CONSULTANT:		CONSULTANT:		ARCHITECT/ENGINEERS:		Drawing Title EXTERIOR ELEVATIONS		Project Title COMMUNITY LIVING CENTER		Project Number 442-12-357		Office of Construction and Facilities Management	
						<div><div>15031 SOUTH PINE BLVD SUITE 200 PARKER, COLORADO 80138 PH: 303-841-9922 WWW.AES-GFP.COM</div></div>				Building Number COWBOY					
RFI #5		21 APRIL 2017						Approved: Project Director		Location CHEYENNE, WYOMING		Drawing Number			
RFI #4		12 APRIL 2017						SYLVIE RUPP - CFM DIRECTOR				AE201			
RFI #3		31 MARCH 2017						FACILITIES/ENGINEERING		Date		Checked			
RFI #2		24 MARCH 2017						PHONE: 307-778-7550x7267		MARCH 2017		DHH			
REQUEST FOR INFORMATION #1 (RFI #1)		16 MARCH 2017						FAX: 307-287-9725		Drawn		JTB			
Revisions:		Date										Dwg. of		 Department of Veterans Affairs

RFI #5	21 APRIL 2017
RFI #4	12 APRIL 2017
RFI #3	31 MARCH 2017
RFI #2	24 MARCH 2017
REQUEST FOR INFORMATION #1 (RFI #1)	16 MARCH 2017
Revisions:	Date

Project Title
COMMUNITY LIVING CENTER

3 EAST ELEVATION
1/8" = 1'-0"

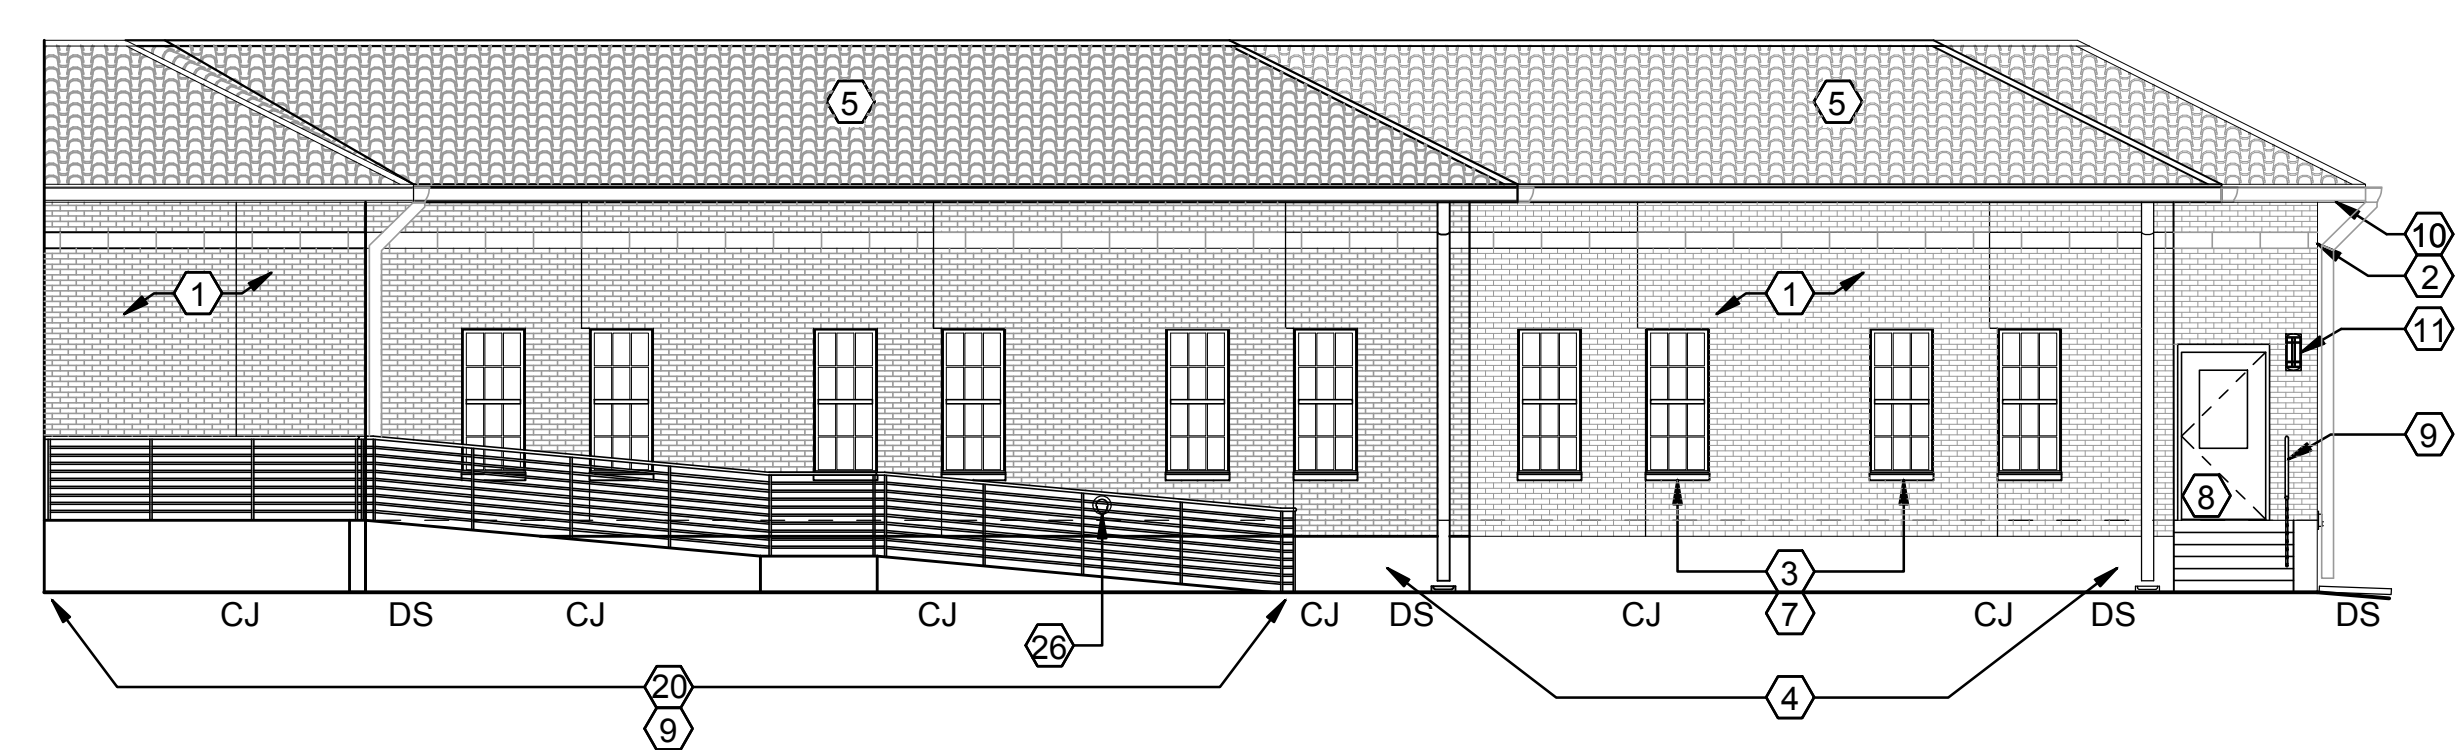
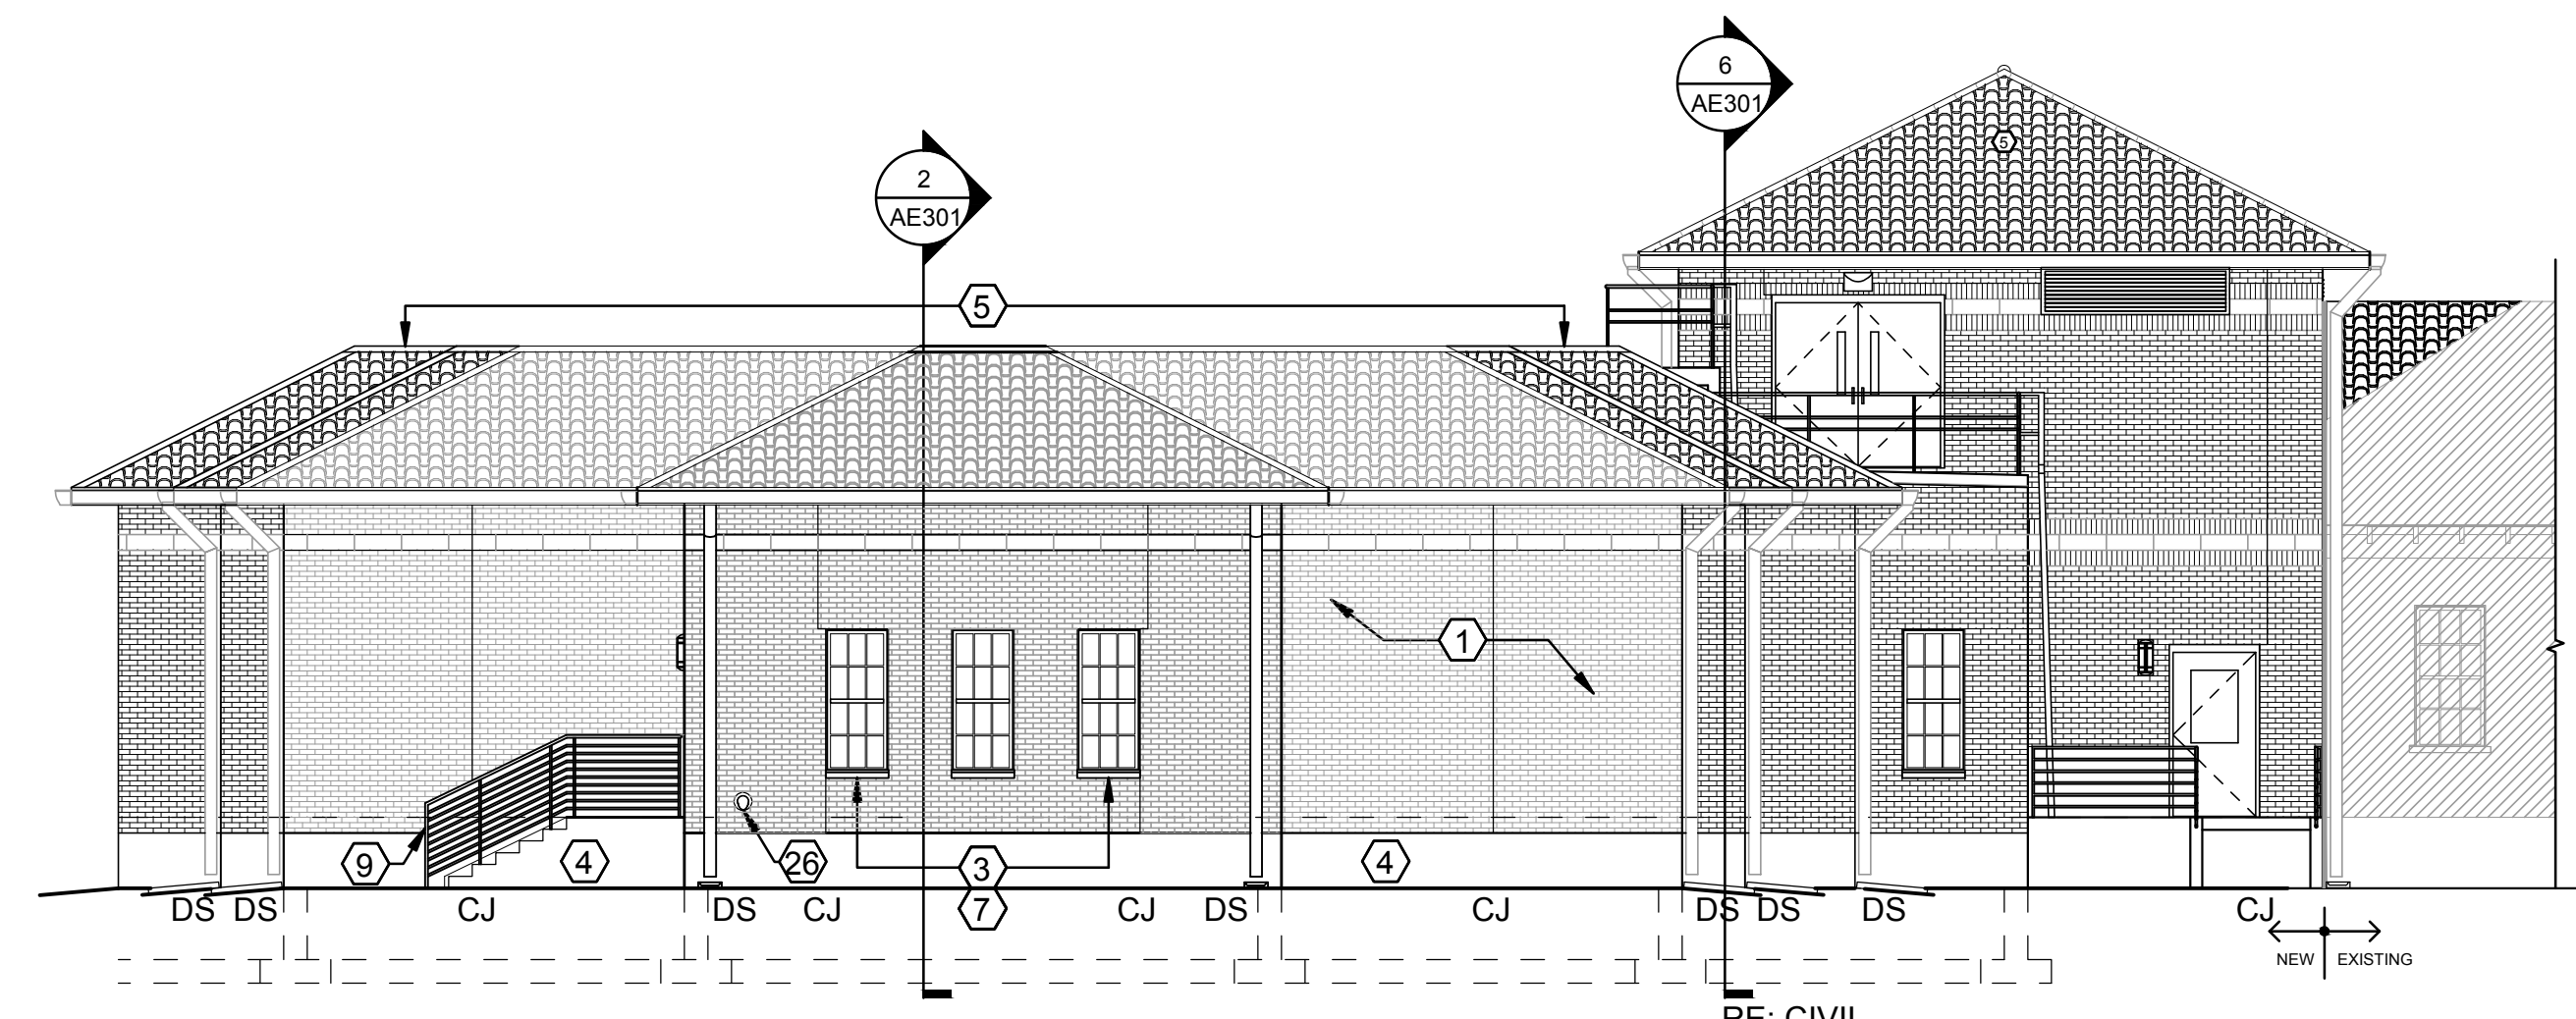
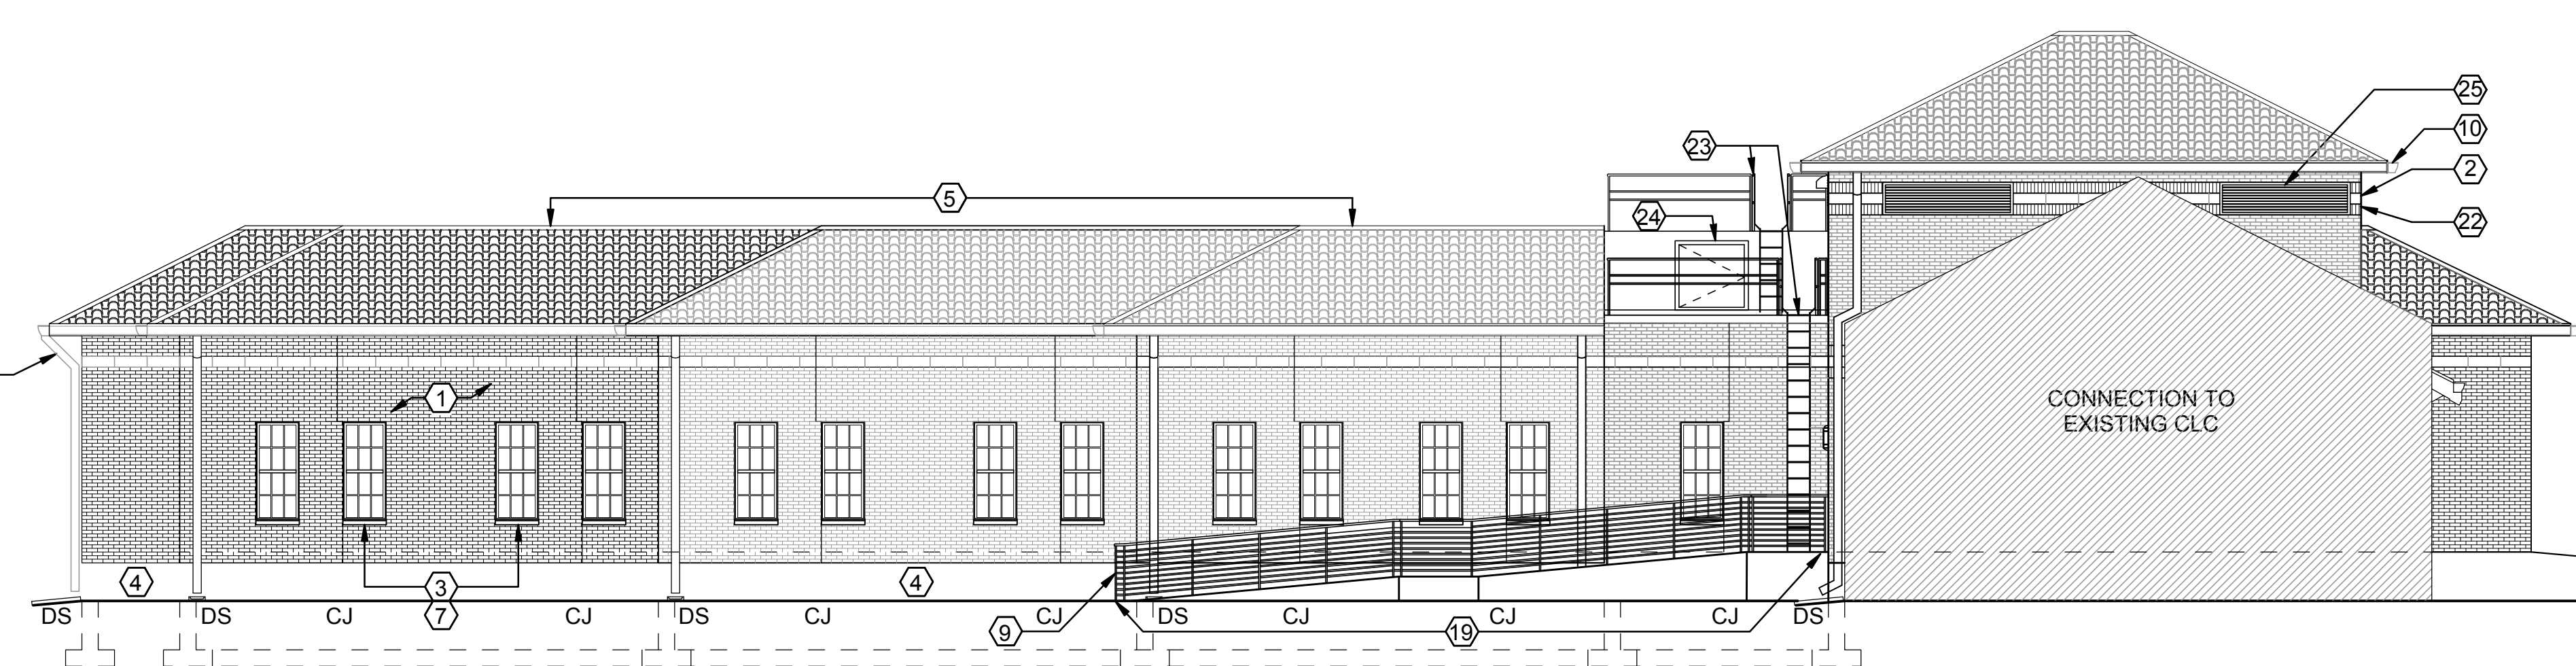
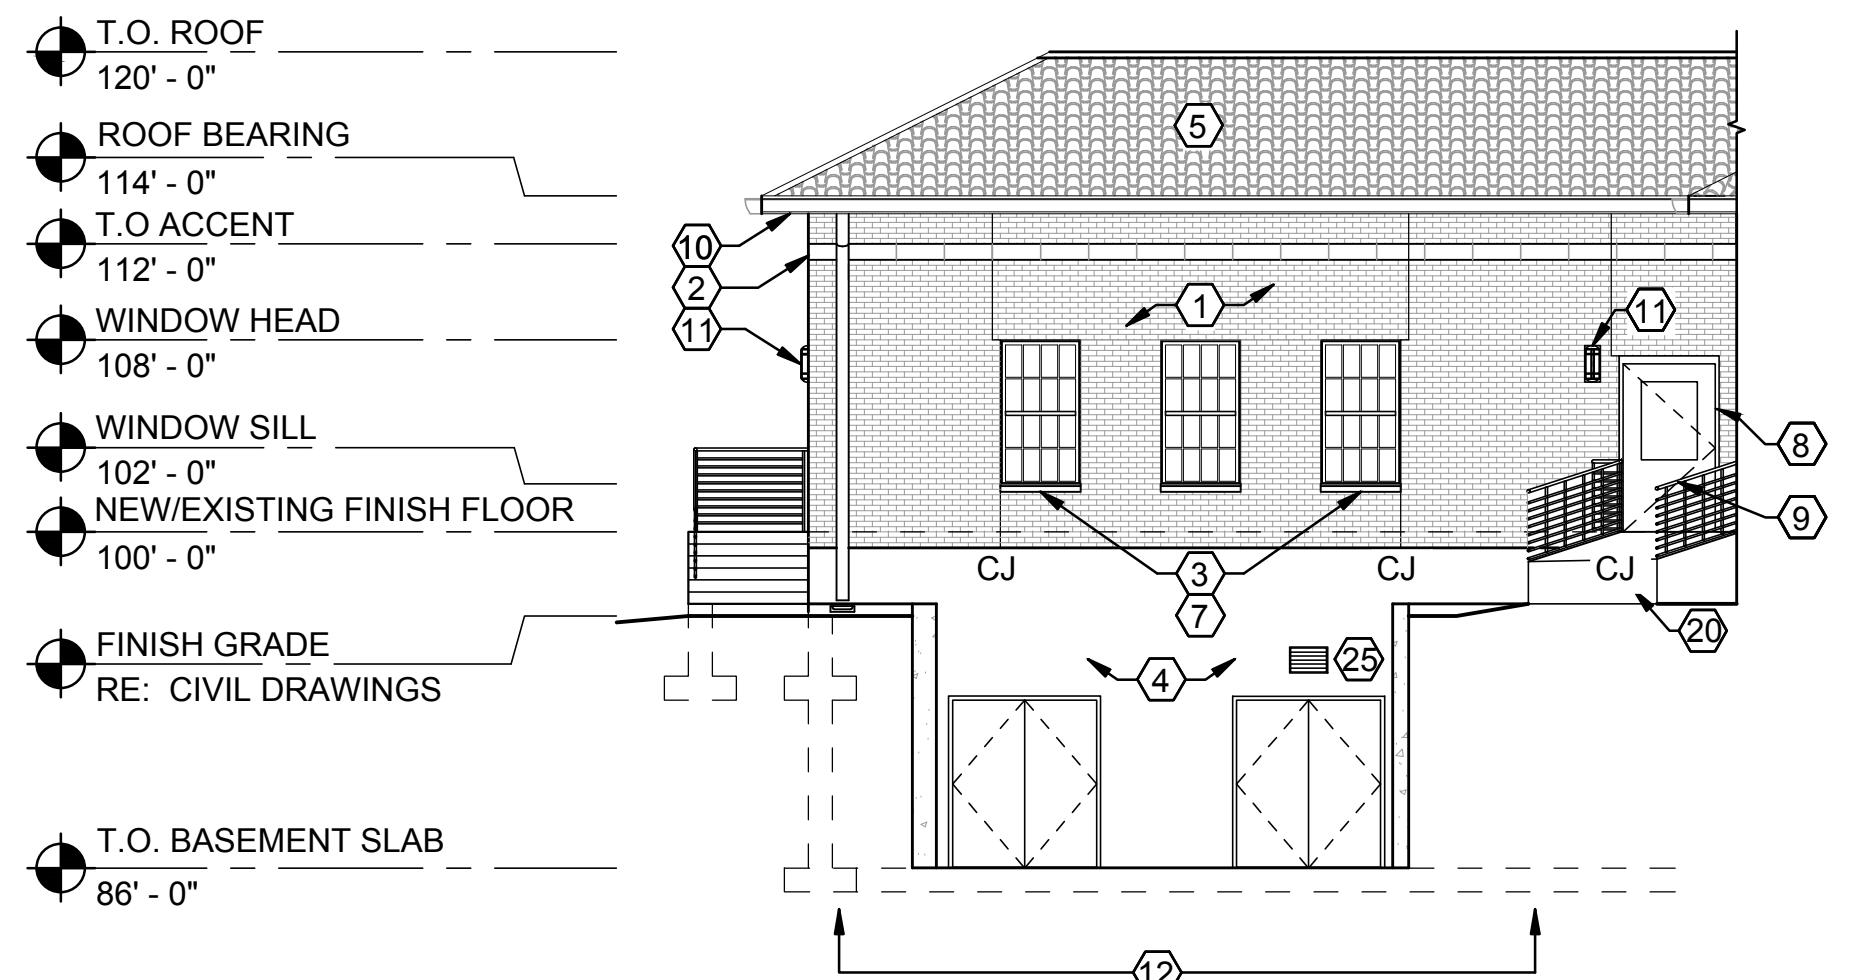
ADJUSTMENT TO SEVERAL CONTROL JOINTS (CJ)
